CITY OF COMMERCE

ADDENDUM #2

RFP 26-011

FY26 LMIG

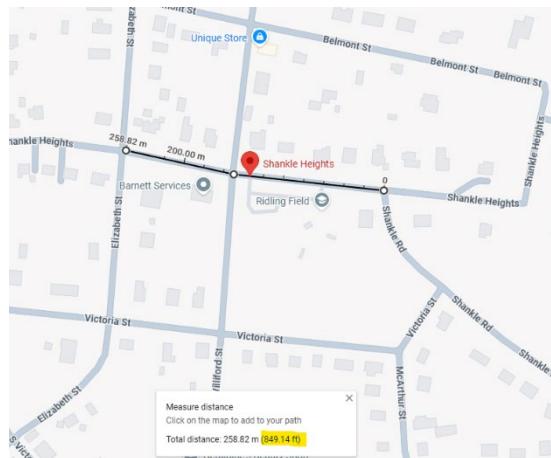
1. On the street list, Shankle Heights is listed from Shankle Rd to Elizabeth St and you have the length being 1800'. I attached a picture that shows that length is close to half of that. Can you please provide if those are the limits and if the 900 feet is accurate?

It starts at Shankle rd. going around the horseshoe turn turning into Belmont st finishing at Elizabeth St. Exiting the horseshoe in both directions 30 ft and the space between is the area being widened approximately 460ft.
